Access Compliance Report Public Rights-of-Way (Curb Ramps)

Main Street: TUCKER_LN Cross Street: FOSTER_RD Location: SE

ADA ID: RPRK211209122955 Ramp Type: Type 1 - Perpendicular Diagonal Initial Pass/Fail: Fail Overall Compliance: No Severity Score: 2

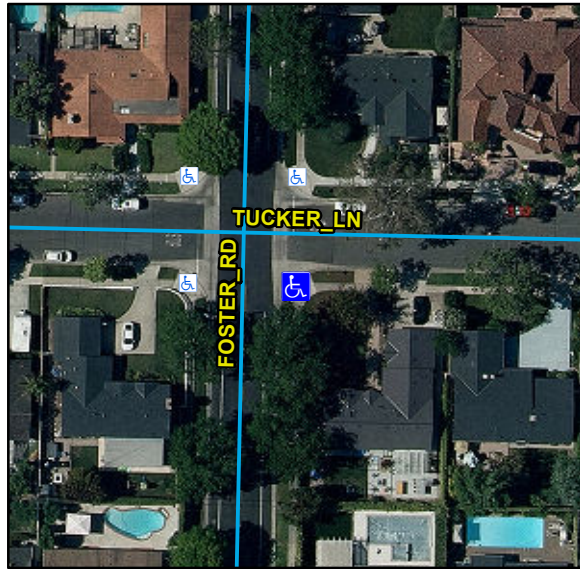
Compliance	Description	Data	Compliance	Description	Data
N/A	Ramp Length (in)	84	N/A	Flare Type LT	
Yes	Ramp Width (in)	48			N/A
Yes	Ramp Run Slope (%)	5.8	N/A	Flare Slope LT (%)	N/A
No	Ramp Cross Slope (%)	2.1	N/A	Flare Traversable LT	N/A
N/A	Landing Present	N/A	N/A	Flare Type RT	
N/A	Landing Length (in)	N/A			N/A
N/A	Landing Width (in)	N/A	N/A	Flare Slope RT (%)	N/A
N/A	Landing Run Slope (%)	N/A	N/A	Flare Traversable RT	N/A
N/A	Landing Cross Slope (%)	N/A	N/A	DWS Provided	N/A
N/A	Landing Movement Obstructed?	N/A	N/A	DWS Contrast	N/A
	Landing Movement Type	N/A	N/A	DWS Length (in)	N/A
N/A	Landing Shared	N/A	N/A	DWS Full Width	N/A
N/A	Clear Space	Yes	N/A	DWS Offset Left (in)	N/A
N/A	Clear Space To Crosswalk (in)	N/A	N/A	DWS Offset Right (in)	N/A
N/A	Marked Crosswalk 1	No	N/A	Marked Crosswalk 2	No
	Crossing 1 Direction	N		Crossing 2 Direction	W
	Marked Crosswalk 1 Width (in)	N/A		Marked Crosswalk 2 Width (in)	N/A

Remove & Replace Curb Ramp With Two New Directional Ramps or Equivalent.
